Product Change Notification (PCN)

PCN #: 11A-2022

Nov 1, 2022

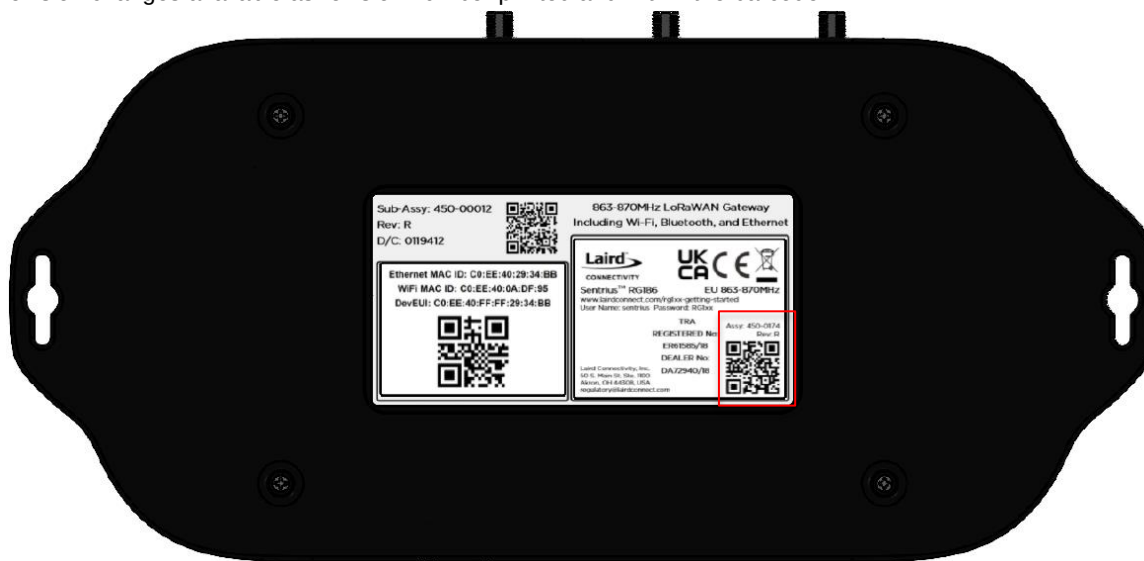
- Specific Part Number Changes: 450-00107-K2
- Added Additional LTE Antenna Port

- GA 6.2 FW update for Sentrius Gateways
- Meet Carrier LTE Compliance
